Tr n-30-1-87728- BY au <b>SUPERSEDED</b> EIOZ-039 EFFECTIVE 5/8/03		New York State Department of Transportation <b>ENGINEERING          INSTRUCTION</b>	<b>EI</b> <b>99-022</b>
<b>Title: REVISED SPECIFICATION FOR PRECAST CONCRETE HEADWALLS FOR 100 mm LATERAL OUTLET PIPES</b>			
Distribution: <input type="checkbox"/> Manufacturers (18) <input type="checkbox"/> Surveyors (33) <input checked="" type="checkbox"/> Main Office (30) <input checked="" type="checkbox"/> Consultants (34) <input type="checkbox"/> Local Govt. (31) <input type="checkbox"/> Contractors (39) <input checked="" type="checkbox"/> Regions/Agencies (32) <input type="checkbox"/> _____ ( )	Approved:  <u>7/2/99</u> P. J. Mack, Director, Technical Services Division      Date  <u>7-6-99</u> J. Tynan, Director, Construction Division      Date

Replace Items 18605.2501M and 18605.2501 with Items 18605.2502 M and 18605.2502 respectively. The new specification addresses field performance problems of the precast headwall pulling away from the 100 mm outlet pipe and the rodent screen coming out of its slotted opening. To address these problems the following changes have been made:

**PRECAST CONCRETE OUTLET HEADWALL**

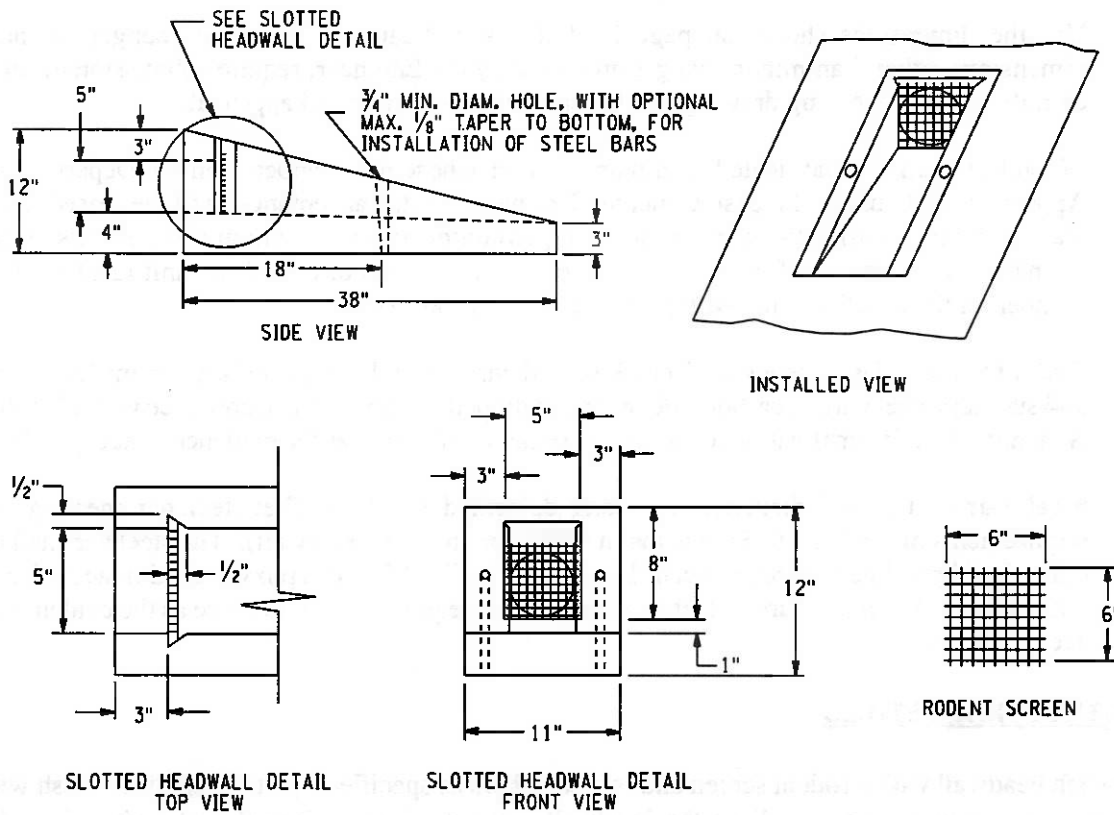
- addition of two 600 mm long steel bars for securing the headwall to the side slope,
- addition of two holes cast into the headwall to accommodate the steel bars,
- reduction of the size of the slotted opening so the rodent screen fits more securely and,
- specifying the rodent screen be welded wire mesh.

Install each headwall with a rodent screen and two steel bars as specified. Install headwalls flush with the finished slope and orient to allow the headwall apron to drain. Extend outlet pipes into the headwall fitting until flush with the installed rodent screen. Install a steel bar in each of the two holes, driven to a minimum of ½" and a maximum of 2" below the top surface of the headwall.
